## APPLICATION FOR DOWNTOWN OVERLAY DISTRICT REVIEW

APPLICATION #: DOD-6-26  
APPLICANT: Toledo Lucas County Port Authority  
OWNER: Board of Lucas County Commissioners  
LOCATION: 114 N. 13<sup>th</sup> Street  
ZONING: Regional Commercial (CR)  
NEIGHBORHOOD: Downtown  
REPORT DATE: June 26, 2026  
HEARING DATE: July 9, 2026  
STAFF REVIEWER: Karcher

**Proposed Site Plan:**

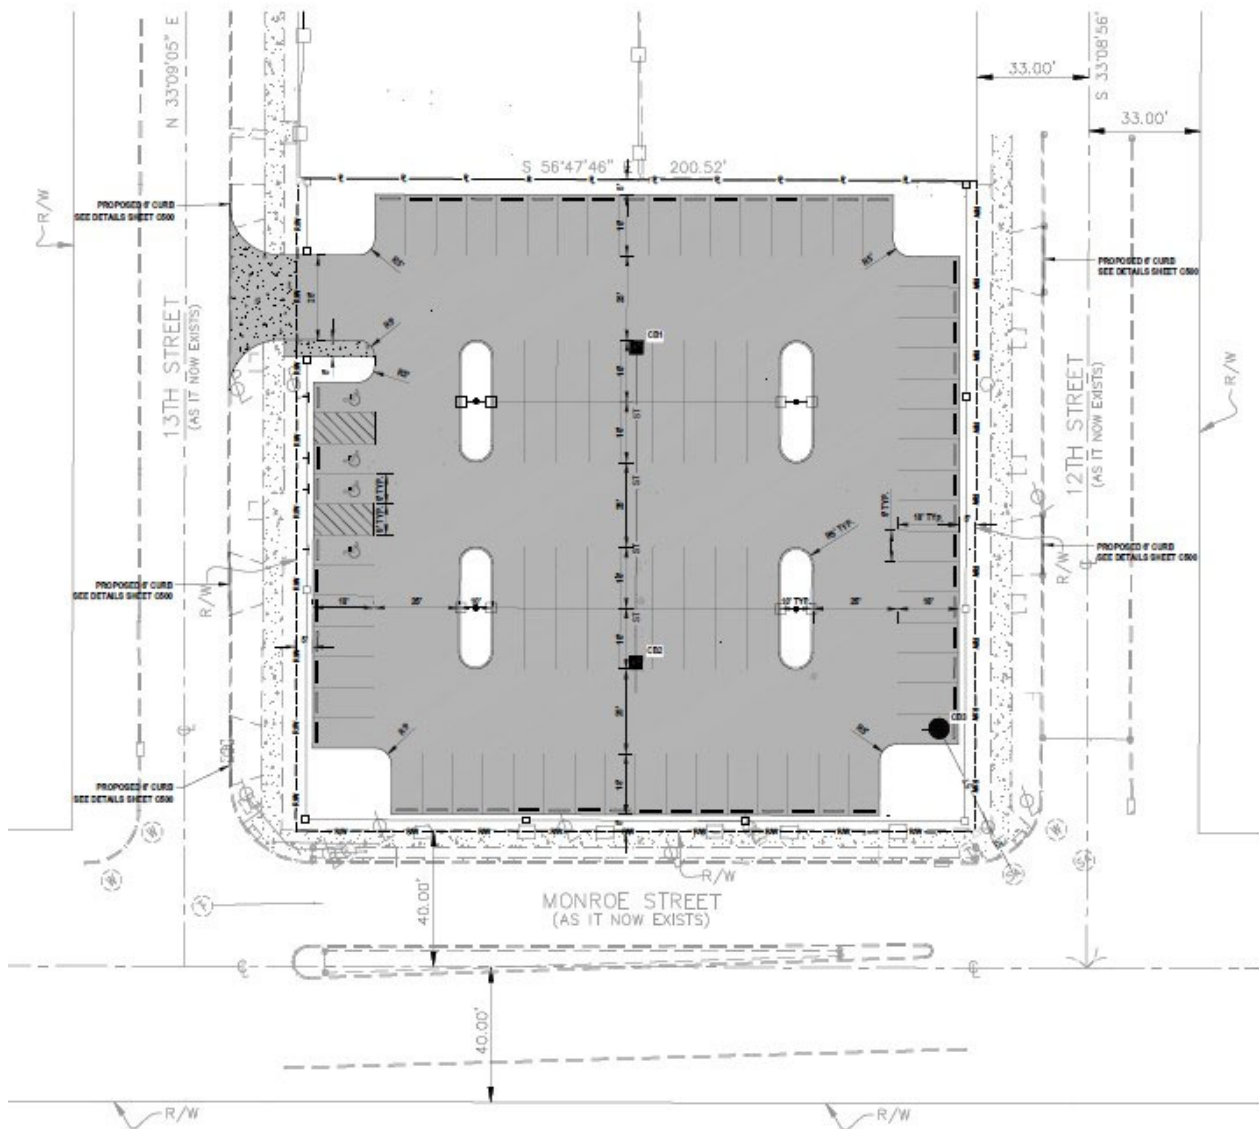
- (b) *Special Design Standards - Surface Parking Lots (TMC§1103.0207)*. Parking spaces in Surface Parking Lots in the Downtown Overlay District that abut fencing required by this Section shall have wheel stops of 4" high or a continuous 4 inch concrete inside the fence placed as to prevent cars from hitting or damaging the fence or columns. Wheel stops are depicted on the site plan for all perimeter parking spaces. - Acceptable

**Proposed Landscape Plan:**

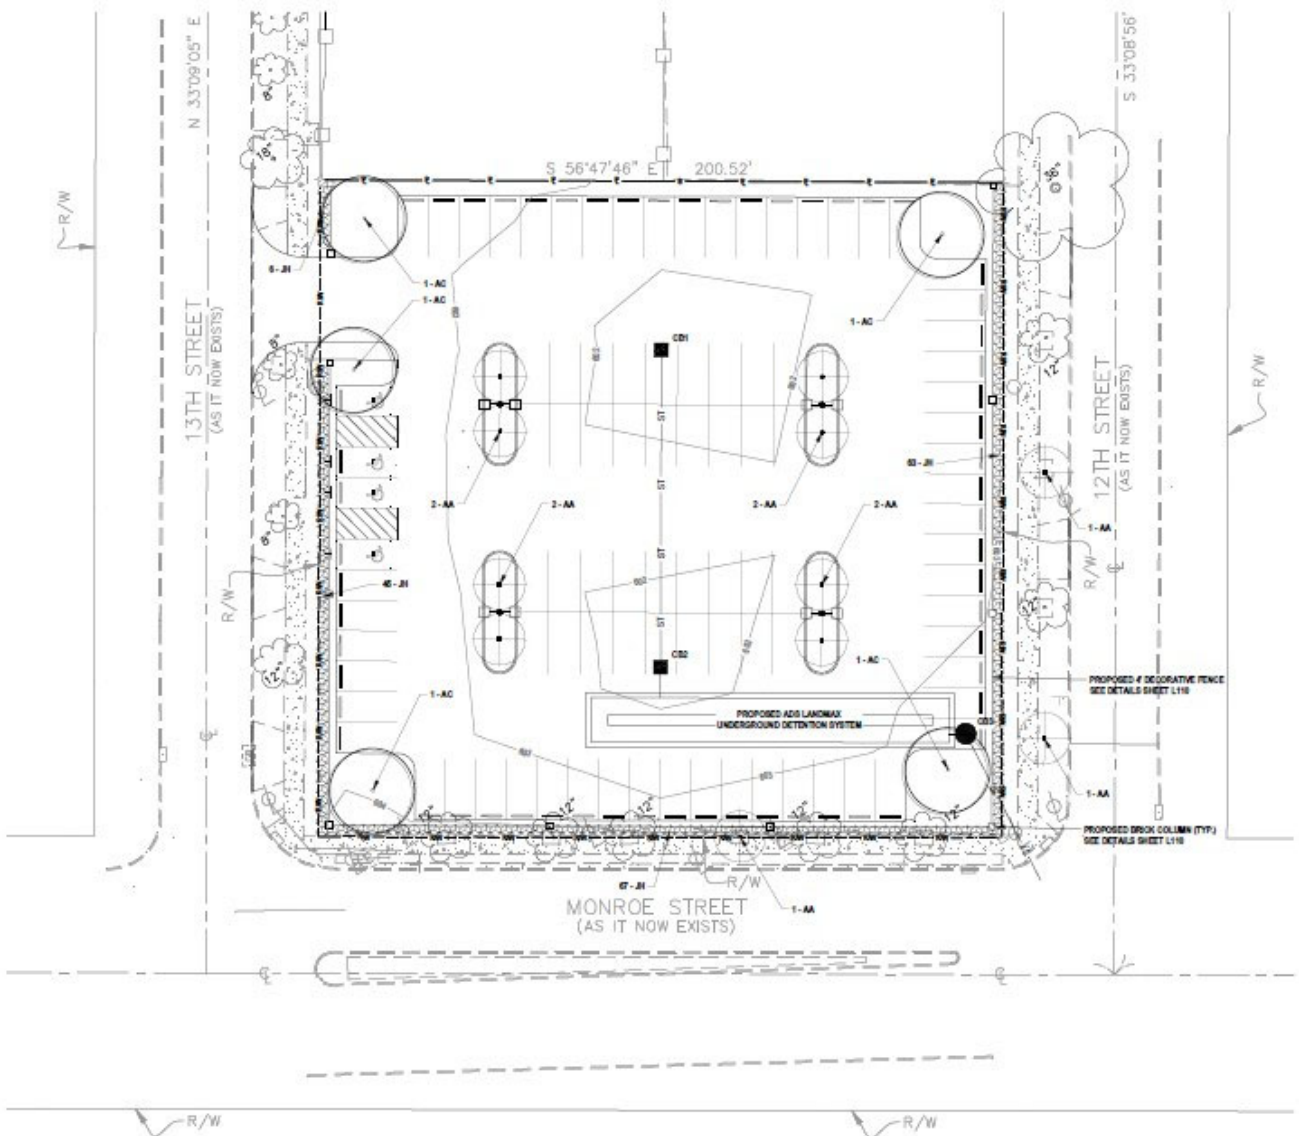
- (a) *Special Design Standards - Surface Parking Lots (TMC§1103.0207)*. Surface Parking Lots in the Downtown Overlay district shall be bordered along public rights of way by black wrought iron or black heavy gauge aluminum tube fencing that is at least four feet high with brick or thin brick columns that are at least 4'6" high and at least 18" wide or greater. Columns shall be constructed using earth tone colors. On primary streets, spacing of columns shall be at least every 24' for small lots (120' x 120' and under) and at least every 60' for large lots (with frontage of more than 120'). On non-primary streets, spacing of columns may be spaced no more than 90' apart. The proposed fence is forty-two (42") tall. The brick columns are not depicted. - Not acceptable

1. The proposed parking lot perimeter fence shall meet the standards in TMC§1103.0207. Not acceptable as depicted. A revised landscape plan shall be submitted that complies with this section.
2. Wheel stops are required for all parking spaces that abut fencing required in TMC§1103.0207. Acceptable as submitted.
3. Lighting fixtures located on the brick columns are encouraged, but not required.
